ATTACHMENT 1

LIQUEFIED NATURAL GAS (LNG) RECEIVING TERMINAL AND
ASSOCIATED FACILITIES

- FURTHER INFORMATION REQUESTED BY EPD -

Figure 1 - Previous Alignment of Tonggu Channel passing through HKSAR Waters

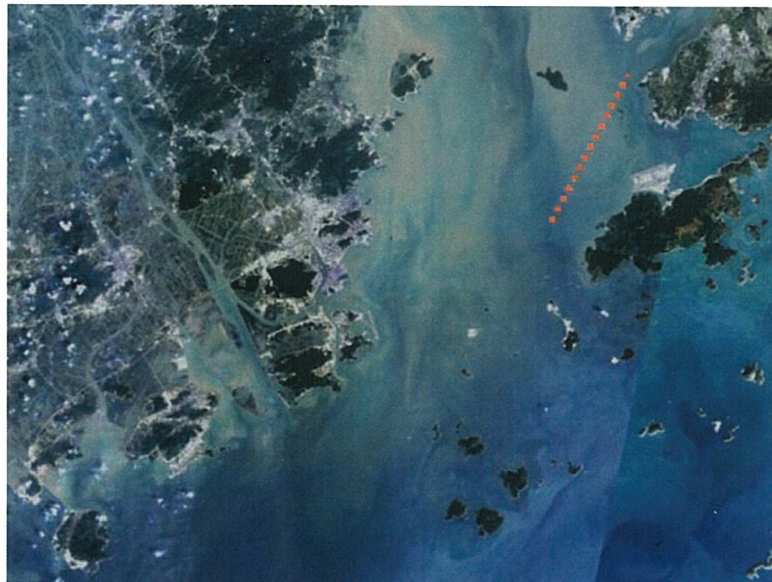
CAPCO understand that the Tonggu Channel Project was proposed 14 May 2003 ⁽¹⁾ and an EIA for the section of the route in Hong Kong waters was rejected by EPD on 24 March 2005 ⁽²⁾. The previously proposed alignment is shown in red on *Figure 1* below.

LNG Terminal South Soko Island LVIA
 Visual Impacts Photomontage VSR 7: Big Buddha
 Further Information to EPD on LVIA Issues - Figure 5

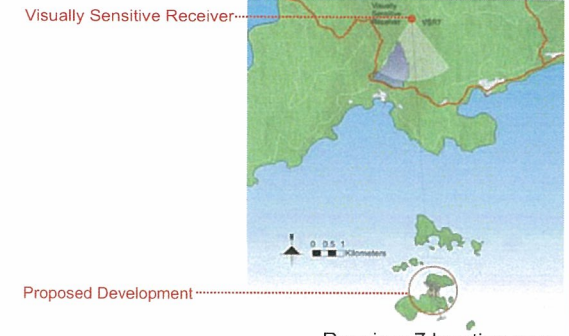
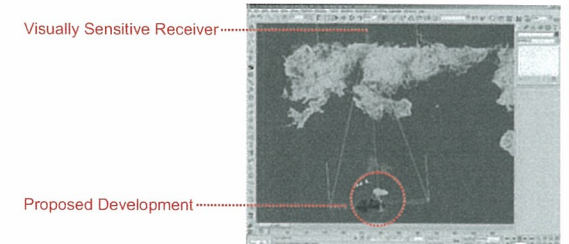
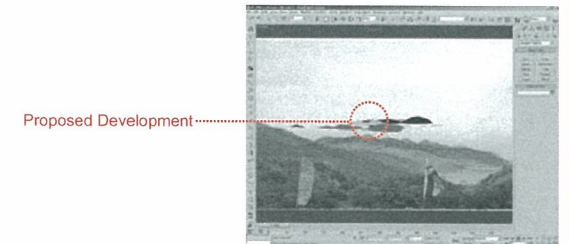
Due to the large distance between the LNG Terminal and Lantau Island, the visual impacts to VSRs located on South-West Lantau will be lower. The only VSR group to experience even a *Moderate* impact are those located at Tai Long Wan Tsuen. The Macau Ferry users and walkers on the Fan Lau peninsula will experience *Slight-Moderate* impacts. Visitors to the Big Buddha along with those in Shek Mun Sha, Cheung Sha Beach Lower and Sunset Peak will only experience a *Slight* impact. All of the remaining 6 VSRs will experience a *Negligible* impact.

Further Information to EPD on LVIA Issues - Figure 6

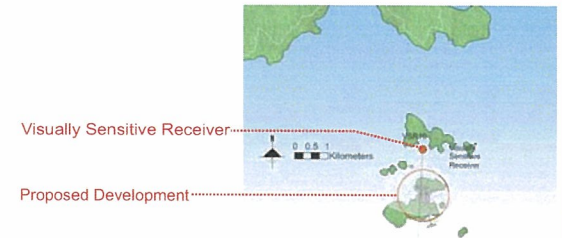
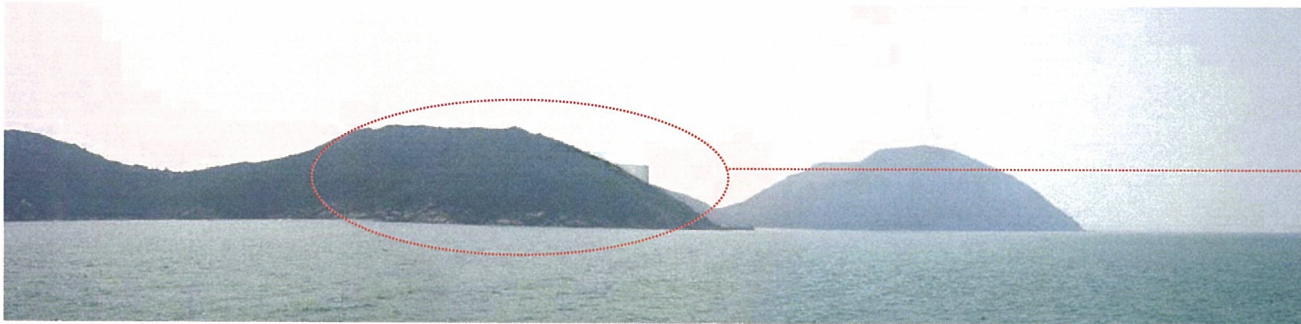
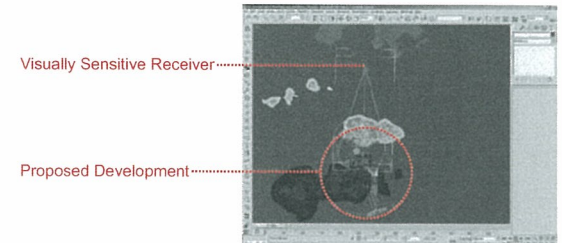
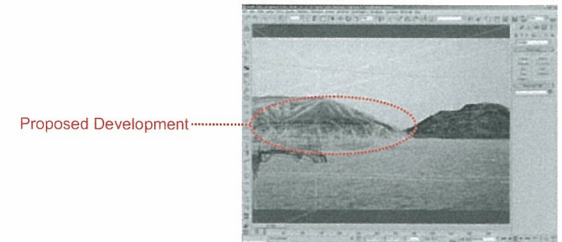
Of the 15 Visually Sensitive Receivers (VSRs) analysed in the study, only marine visitors off South Soko Island will experience a *Significant* impact with visitors to North Soko Island experiencing a *Moderate/Significant* impact. Both of these VSRs are located in close proximity to the LNG Terminal and experience low visitor numbers.

Further Information to EPD on LVIA Issues - Figure 8

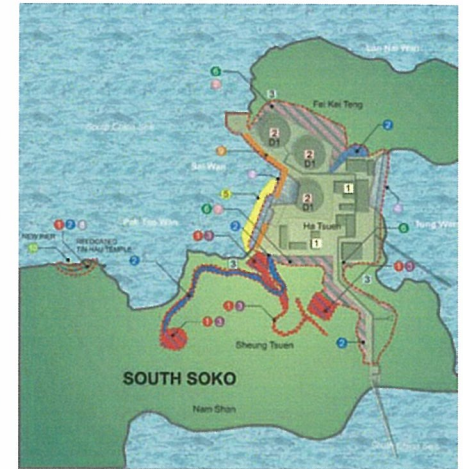
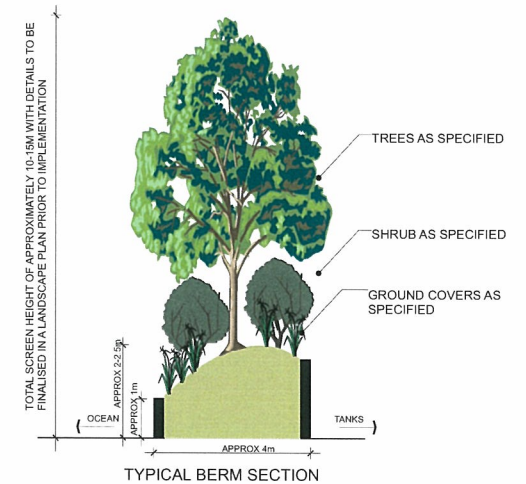
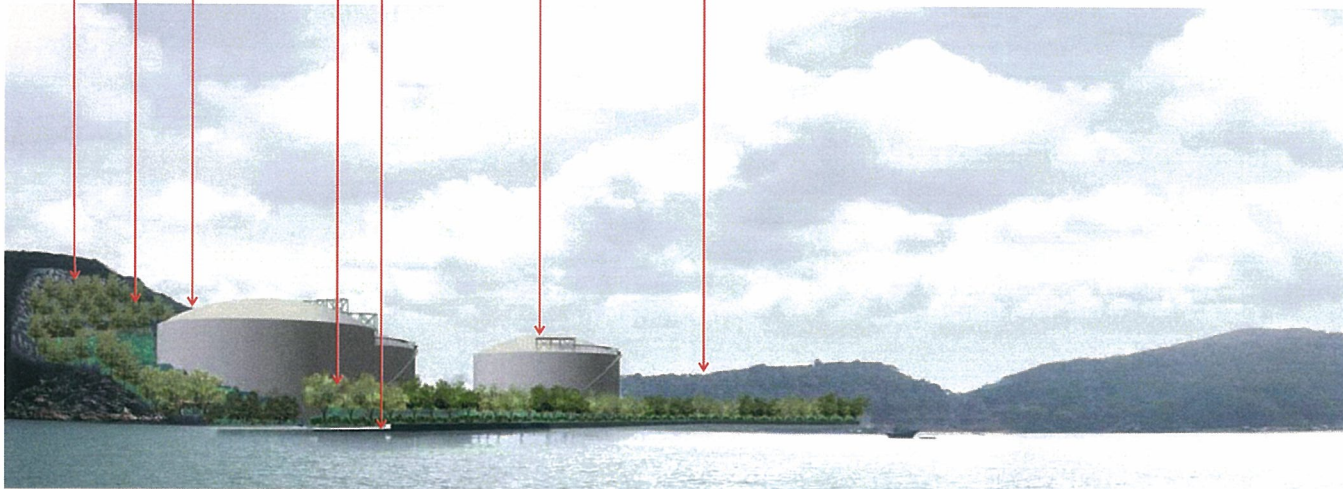
Bench plantings.
Cut slopes have been benched to allow for planting of shrub and climbers species that will reduce the visibility and impact of the slope.

Soil stabilisation and planting.
During the design process a soil stabilisation and planting strategy will be prepared to ensure that all land affected by slope excavation can be replanted. Soil preparation and the selection of suitable growing medium is to be in accordance with the relevant best practice guidelines.

Tree and shrub planting.
Planting of trees and shrubs is to be carried out in order to achieve a finished landscape that integrates with the character of the surrounding undisturbed landscape.

Landscape Berm/Planter.
A 2m high bund will be constructed and planted with fast growth indigenous trees and shrubs to help filter views to the tanks.

VMM3 plantings.
In addition to the landscape mitigation set out above, appropriate new plantings will be undertaken to further integrate new structures with the surrounding landscape.

The Landscape and Visual Mitigation Plan (refer Figure 11.20 EIA Report-Part 2) has been prepared to implement a strategy that reduces the potential impacts on existing landscape resources and where possible enhances existing landscape qualities. Several of these measures are identified in the photomontage above, which displays the proposed development Year 10 with mitigation.
